Customer : CU-DAR001 Dart Helicopters Services	Drawing Name : GROUND HANDLING HARDWARE CHG
Job Number : 47108	
Estimate Number : 13703	
P.O. Number :	Part Number : DSI 9435011
This Issue : 13/04/2009 S.O. No. :	Drawing Number : DSI9435 REV A
Prsht Rev. : NC	Project Number : N/A
First Issue : / / Type : MACHINED PARTS	Drawing Revision : A
Previous Run : 46466	Material :
Written By :	Due Date : 13/04/2009 Qty: 1 Um: Each
Checked & Approved By : <u>JUD 09.04.13</u>	
Comment : Est Rev:A New Issue 08.12.19 DD verified by:EC

DART SERVICE INSTRUCTION

TO AMEND INSTALLATION INSTRUCTIONS IIN-D117-762 REV. A AND
INSTRUCTIONS FOR CONTINUED AIRWORTHINESS ICA-D117-762 REV. 0

D117-762-011 SKIDTUBE

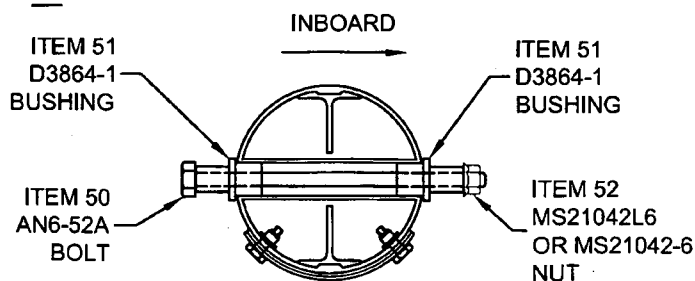
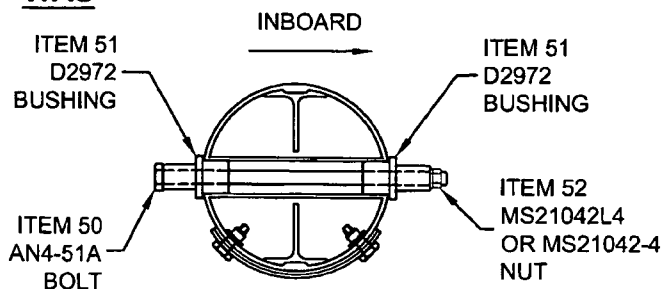
ON D117-762-011 SKIDTUBES AT CHG 002, THE GROUND HANDLING HARDWARE HAS BEEN REPLACED WITH AN6-52A BOLT (1), D3864-1 BUSHING (2), AND MS21042L6 NUT (1) AS SHOWN BELOW. TORQUE TO 95-110 IN-LBS (10.7-12.4 N-M). AMEND PARTS LIST IN SECTIONS 5.1 OF INSTALLATION INSTRUCTIONS IIN-D117-762 REV. A AND SECTION 32.8 OF THE INSTRUCTIONS FOR CONTINUED AIRWORTHINESS ICA-D117-762 REV 0 AS SHOWN ON PAGE 2 OF THIS DOCUMENT.

IS

WAS
